# Groundwater Transfer Review Summary Form

Transfer/PA # T- 13861

Application: T-13861

Applicant Name: Stauffer Farms Inc.

Drawdown calculations for MARI 69905 impacts to neighboring MARI 51008 at currently authorized rate of 0.673 CFS. Increases in rate at this proposed APOA may result in injury to neighboring right Certificate 92328.

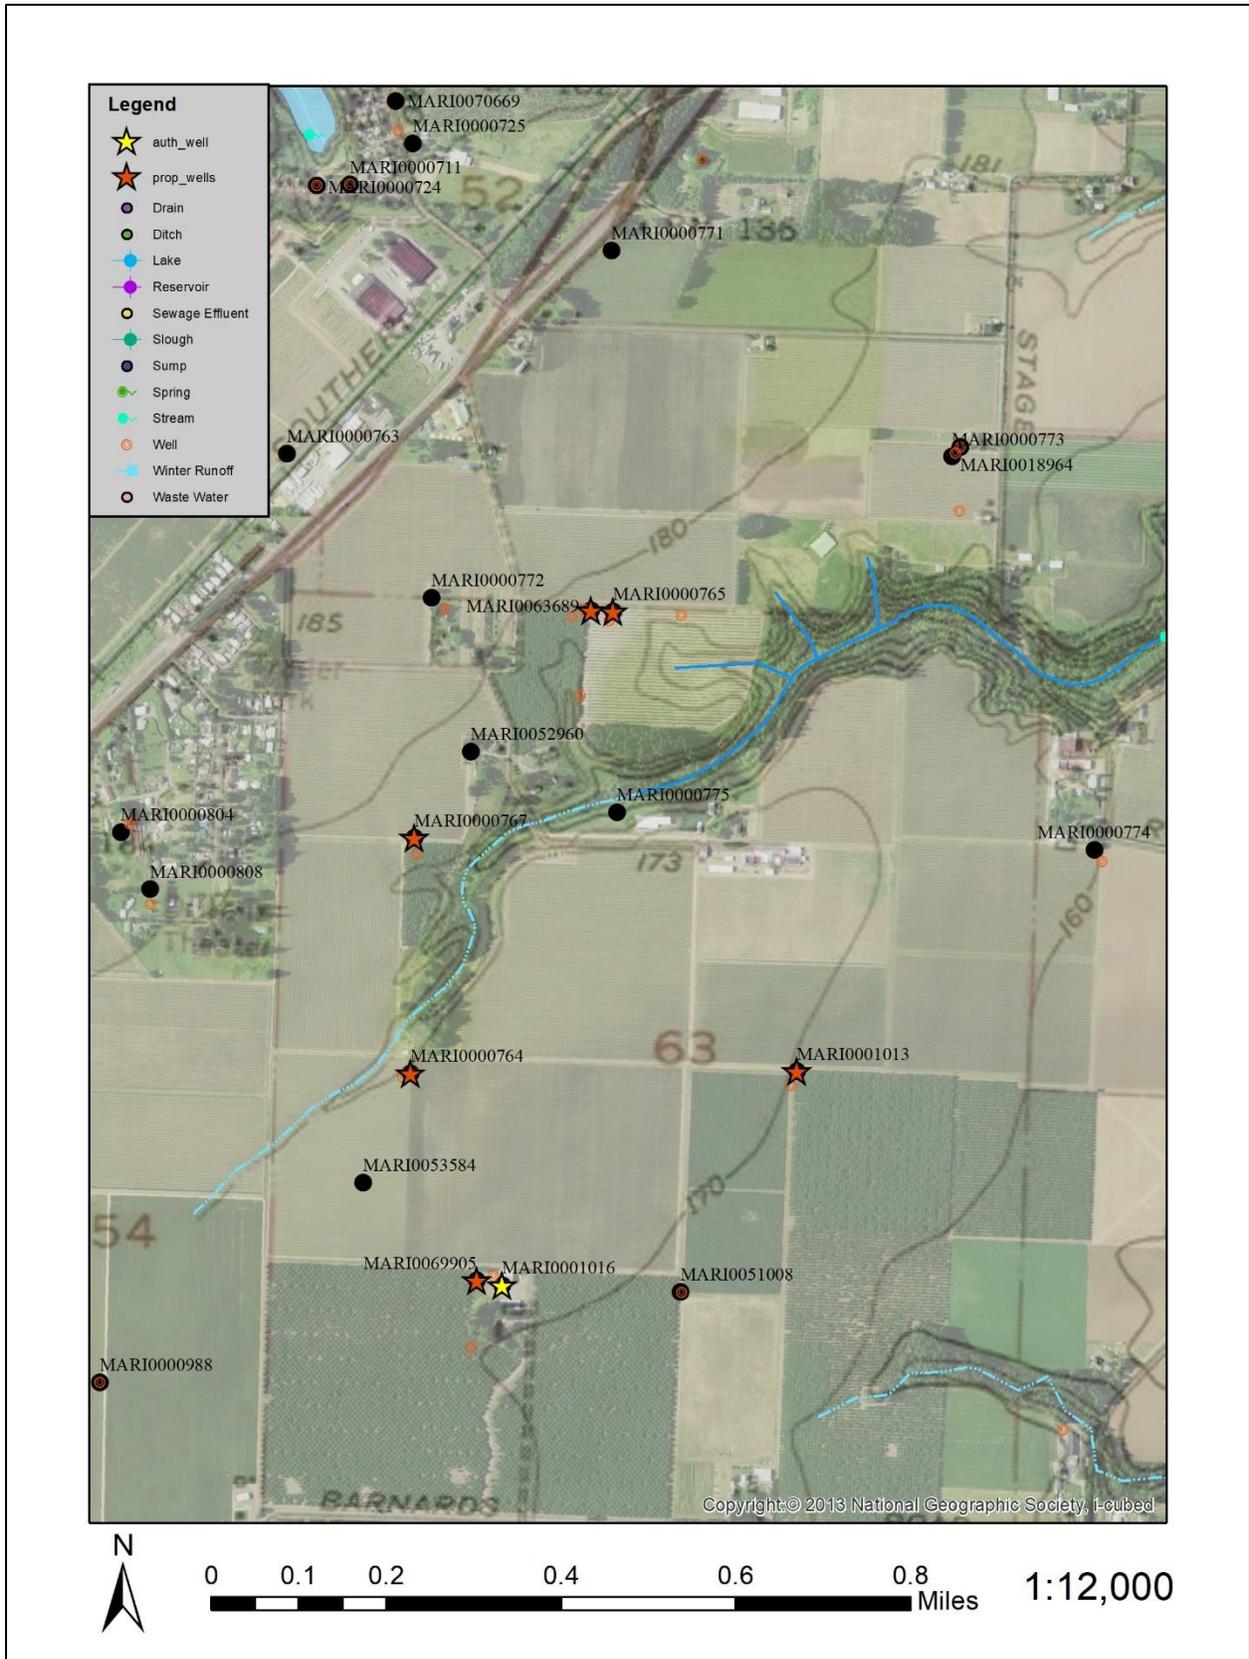
MARI 69905 is currently authorized under Permit G-18537 at a maximum rate of 0.673 CFS, limited by the 80% exceedance flow in the resident WAB. Using parameters included in the original application review (G-18923; Travis Brown), an increase in pumping as a result of this transfer is likely to cause injury at MARI 51008, with expected seasonal drawdowns between 15-50 feet. If the maximum rate at MARI 69905 is maintained at the authorized rate under G-18537, however, the most reasonable estimates of drawdown lie between 11-16 feet.

7. What conditions or other changes in the application are necessary to address any potential issues identified above: Production from MARI 69905 shall be limited to rates and duties authorized under GR-751 and Permit G-18357.

**Cross-section diagram showing positions and screened intervals within APOA MARI 69905, abandoned POA MARI 1016, and neighboring well MARI 51008. Water-bearing horizons of coarse-grained material appear to be consistent in thickness and depth in the area of the proposed actions.**

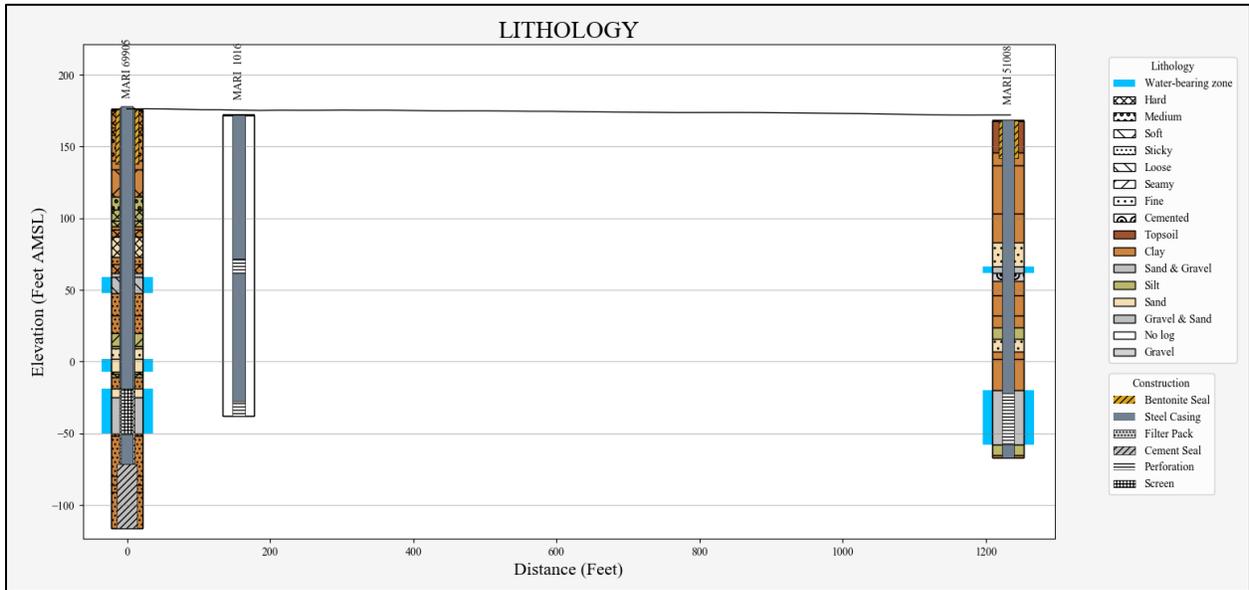
2. Will the proposed POA develop the same aquifer (source) as the existing authorized POA?  
 Yes     No    Comments: All wells produce groundwater from alluvium.
